**PIERCE MANUFACTURING, INC.**

Vehicle Recall **09V-xxx** Velocity/Impel Battery Box

# Velocity/Impel Battery Box Upgrade

### Install spacer

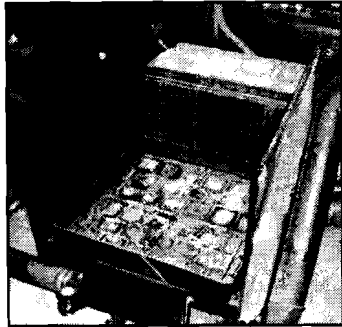
Install spacer on **front** side of battery box.

Using spacer as template, drill three 9/32" dia. holes through front side of battery box. Be careful to clear discharge and front suction pipes.

Install three 1/4" bolts and serrated nuts to hold spacer in position. Place bolt head on outside of battery box. Tighten to 10-11 ft lb.

### Wrap up

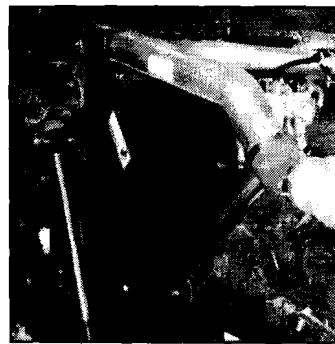
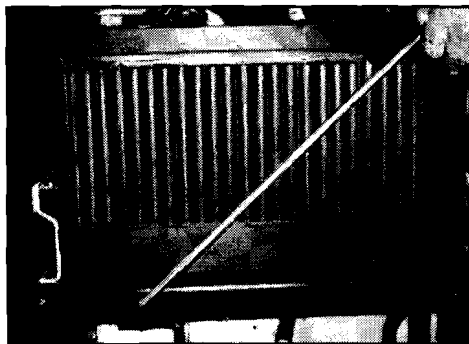
Add battery tray spacer and remove cab insulation on other side of vehicle.

Check battery cable and battery hold down connections.
